Ref: 2022/4794/P and 2023/0106/L

1. This is a further letter to raise concerns and object to the excavation of the studio building at the rear of 28 Charlotte Street London.

Proposed excavation of Artist Studio at Rear of 28 Charlotte Street seen from 7 – 15 Whitfield Street development.

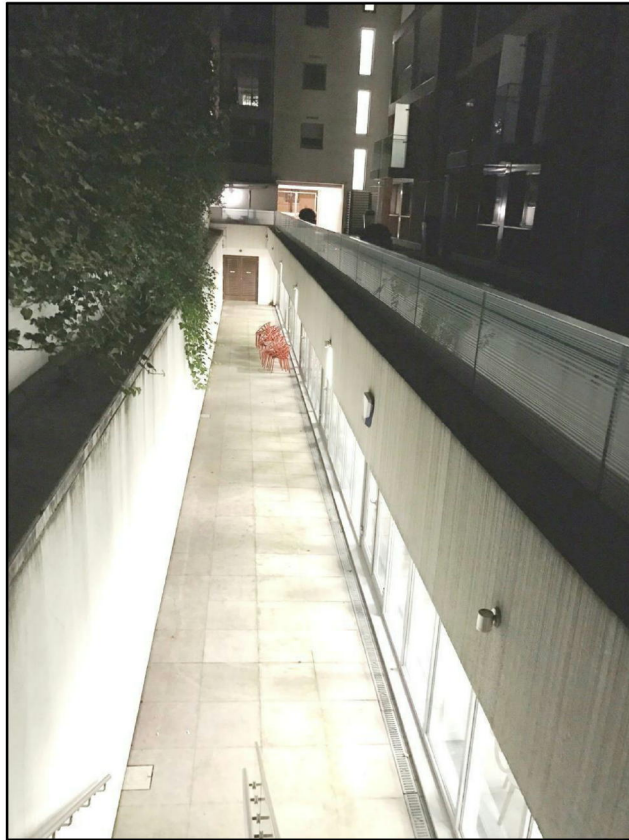
There is a 3-metre distance between no 10 Crabtree Place (building on left) and the proposed excavation to the studio of 28 Charlotte St (building on right)

The buttress on the corner marked with a **GREEN X** of the studio building at 28 Charlotte St shown in brown brick supports the entire studio building. No mention in planning application on how that will be supported or dealt with in the excavation.

The **red circle** shows some of the cracks on the studio wall.

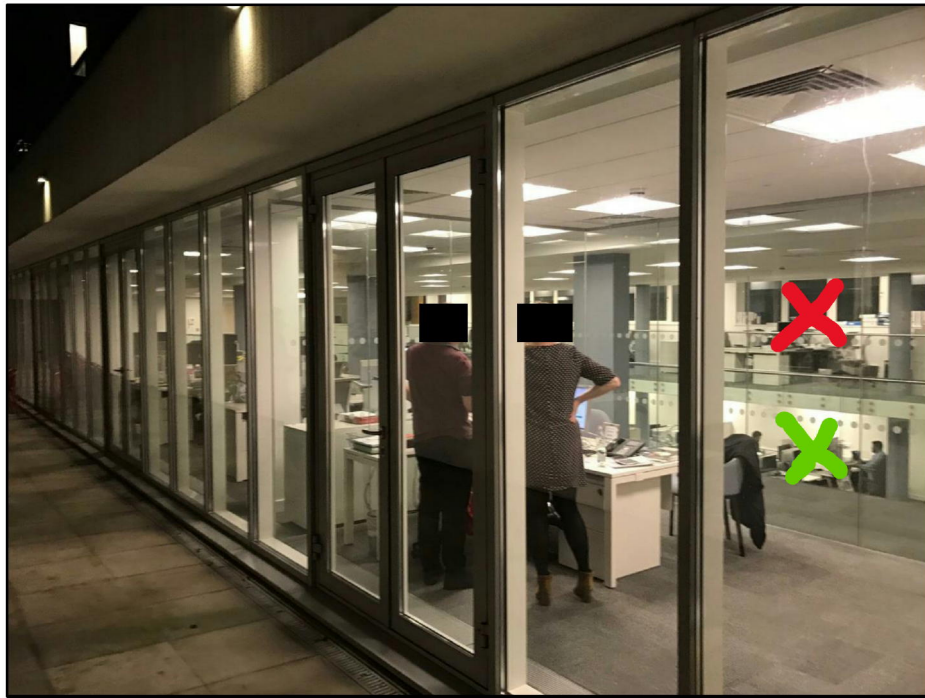
The office basement is 7 metres from the proposed excavation of the studio at 28 Charlotte Street.

7 – 15 Whitfield Street development has an extensive office two level basement below its flats and houses. This basement and its plant room butt onto the proposed development wall and proposed basement excavation.

Photo plant room of the basement offices of 7 -15 Whitfield Street Development marked **GREEN X.**

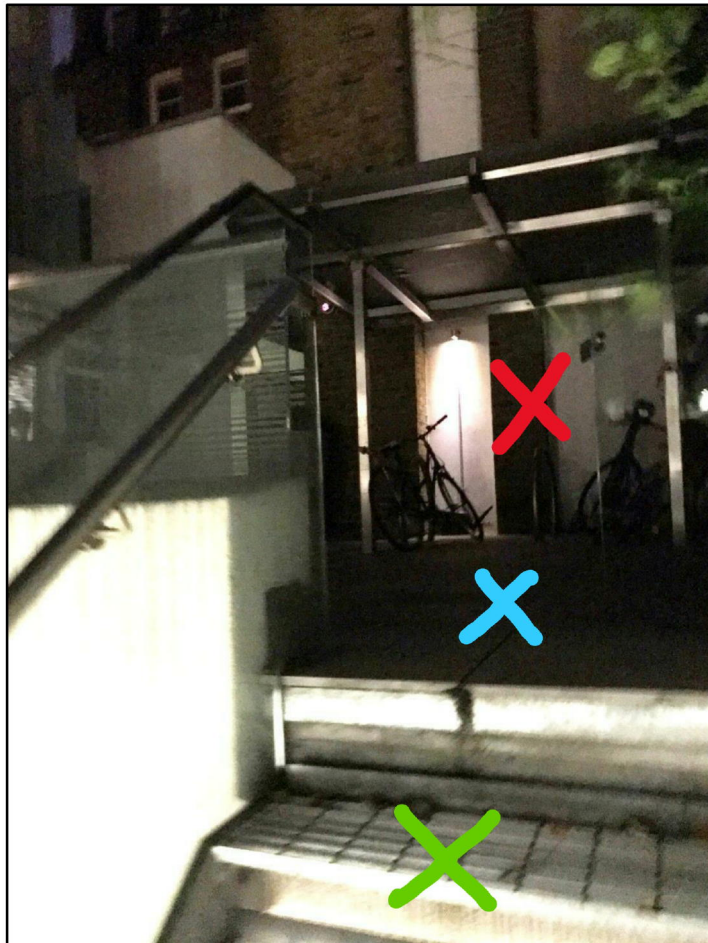
These plant room services have not been considered in the basement excavation as they are abutting the party wall.

The plant room which runs to the end of the party wall to the proposed excavation of the studio at 28 Charlotte Street. No indication has been provided regarding the extent of the basement excavation and its relationship with respect to the services in the plant room which runs to the party wall.
